## Cannondale Motorsports Parts Bulletin

### CLUTCH CABLE REPLACEMENT P/N 213-6000167-02

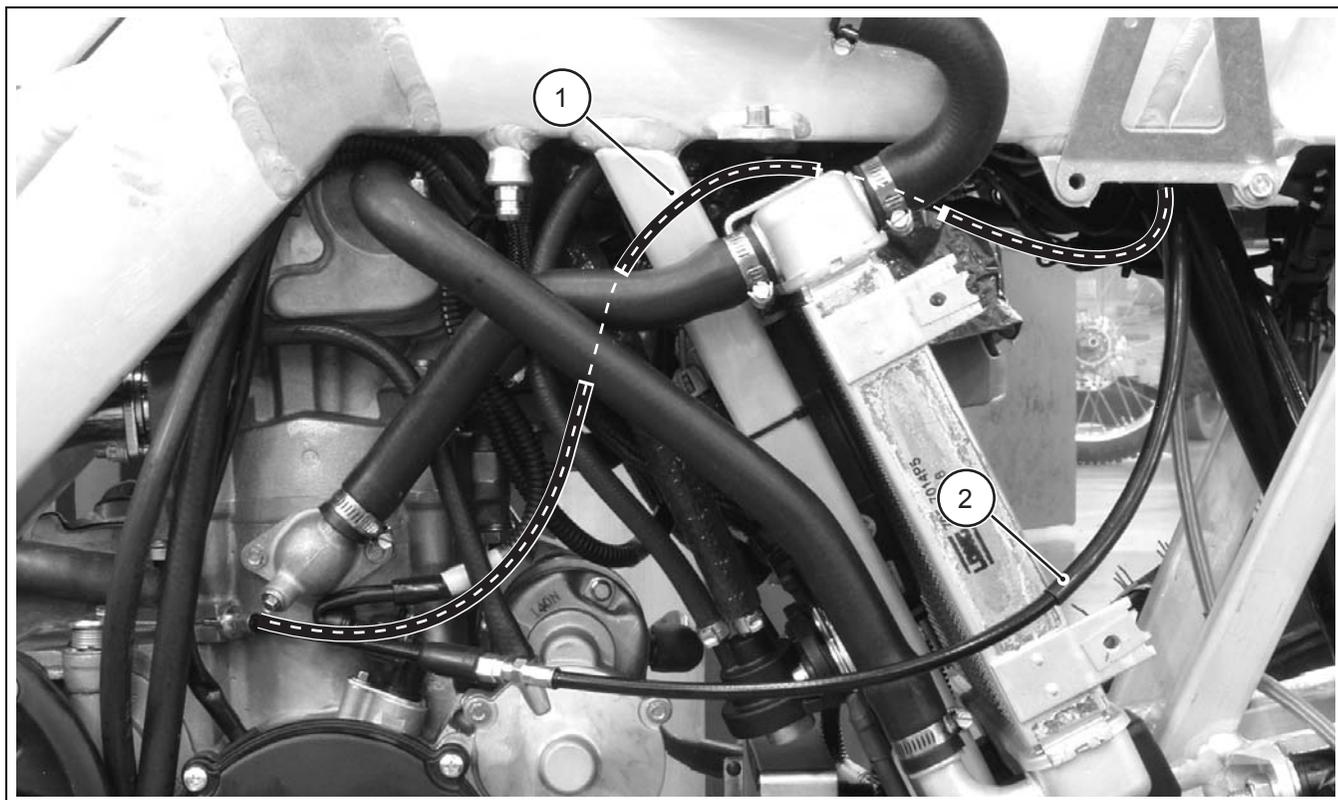
A replacement clutch cable P/N 213-6000167-02, is available as a direct replacement to P/N 213-6000167 for ATVs equipped with a manual clutch. The replacement cable routing is depicted in the photo below. Duplicate the routing of the older cable at the handlebar and steering column (not shown in the photo).

1. Replacement routing
2. Longer cable routing
